Planning and Amenity Delegated Committee Meeting

Tuesday 11 June 2024
at 6.30pm

- 4.3 275 Beach Road, Black Rock Local Law Tree Removal Application: 2024/77 17
 - 4.4 2 James Avenue, Highett Notice of Decision to Grant a Permit Application: 2024/19/1 Ward: Ivison 23

Figure 3: extent of variation to front setback requirement of Standard B6 (front setback)

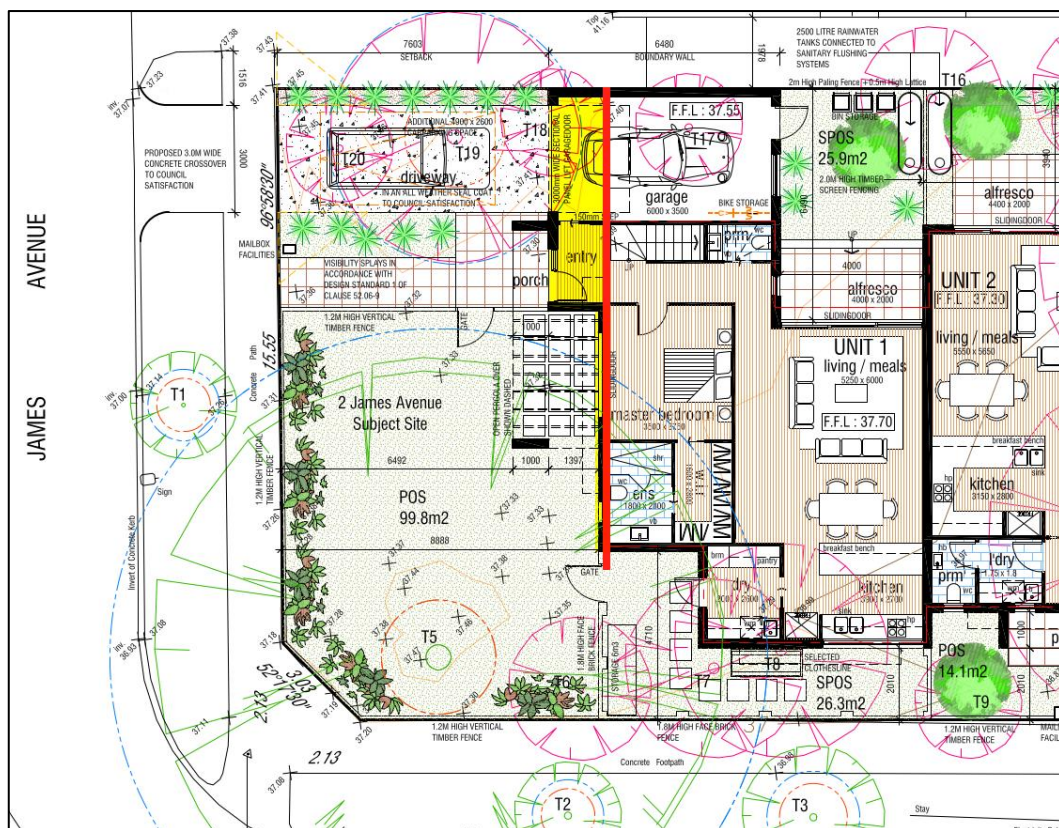
A street setback from James Avenue of 7.603 metres is proposed, when a setback of 9 metres is required to achieve this standard. The extent of this variation is highlighted in the below image.

The objective of the street setback is to ensure the setbacks of buildings from a street respect the existing or preferred neighbourhood character and make efficient use of a site.

retention of Tree 5, which has a maximum height of 15 metres. Similarly, the front garden space allows additional vegetation to be planted including an addition canopy tree with a mature height of 10 metres and lower-level planting. The retention of this tree and additional landscaping will assist in softening the front façade of the dwelling when viewed from the streetscape.

Figure 4: extent of variation to rear setback requirement of Standard B617 (side and rear setback)

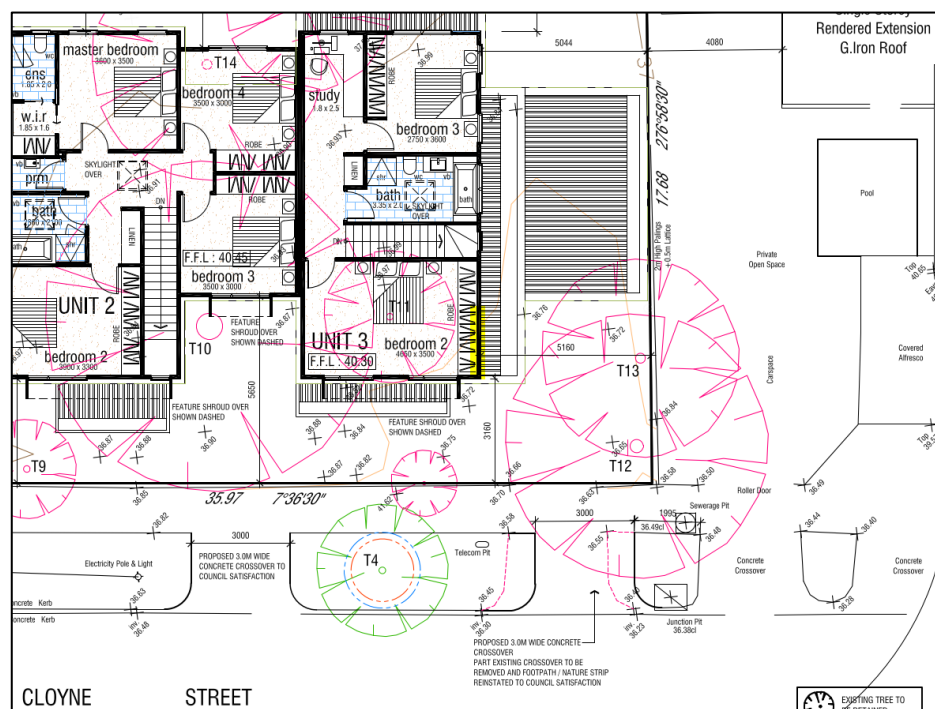
In this instance, the proposal seeks a variation of 0.01m – 0.14m to Bedroom 2 of Dwelling 3 to the southern (rear) boundary. The location of this variation is highlighted in the below image.

The objective of the standard is to ensure the height and setback of a building from a boundary respects the existing or preferred neighbourhood character and limits the impact on the amenity of existing dwellings.

Whilst the extent of the variation is numerically minor it does adjoin a sensitive interface of the primary open space of 1 Cloyne Street which is located to the south of the wall. At ground level there is no opportunity to plant any substantial vegetation adjoining the varied wall. As a result, a condition has been included for this wall to be compliant with the standard. This could be achieved through reducing the wall height or increasing the setback.

- a) bedroom 2 of Dwelling 3 to fully comply with the rear setback requirement of Standard B17 of Clause 55.04-1 of the Bayside Planning Scheme
 - b) pedestrian corner spays to be annotated on both sides of each crossover in accordance with Clause 52.06-9 of the Bayside Planning Scheme and modifications to the proposed fencing to facilitate this requirement
